TAB Punch List - Mar 25, 2024

L05068_Spring Station FSU (KY)

L1020005068

M-250

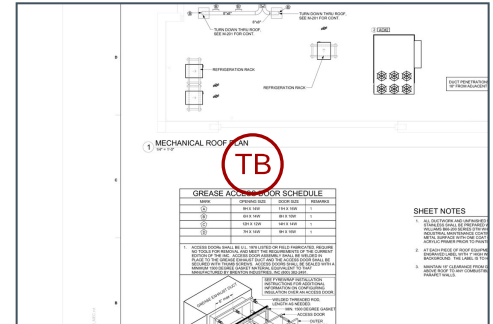
Cleanout doors do not meet size specifications listed in cleanout door schedule on M-250.

M-501

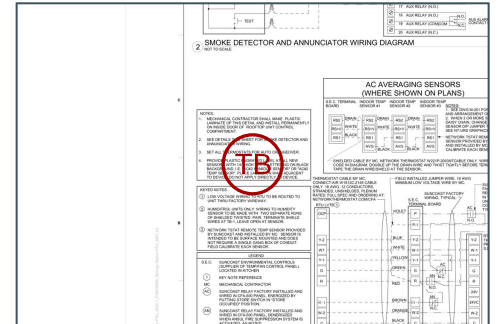
See M-501, Detail 1, Note 4:
1/4" High white
Lettering on black
background. Label on wall
ADJACENT TO DEVICE.
Sensors improperly
Labeled.
